Access Compliance Report Public Rights-of-Way (Curb Ramps)

Main Street: SILVER_FOX_RD		Cross Street: BOSTONIAN_DR		Location:	NE
ADA ID: RPRK211220121816	Ramp Type:Type 1 - Perpendicular Diagonal Initial Pass/Fail: Pass		Overall Compliance: No	Severity Score:	0
Codes/Mitigation Info/Possible Solution			Field Measurements/Component Compliance

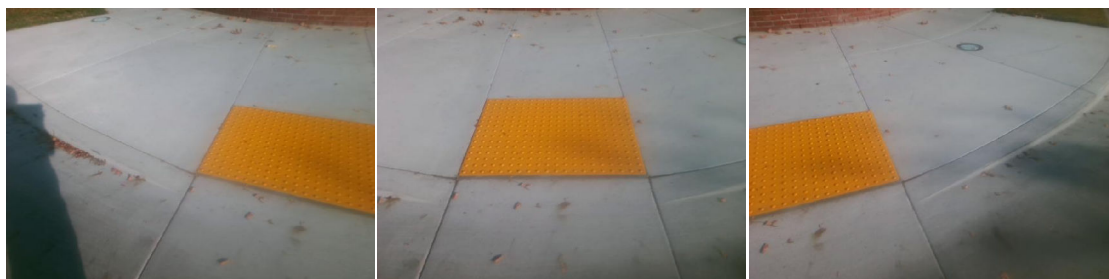
R304.2.1, STD 1115

Remove & Replace Landing.
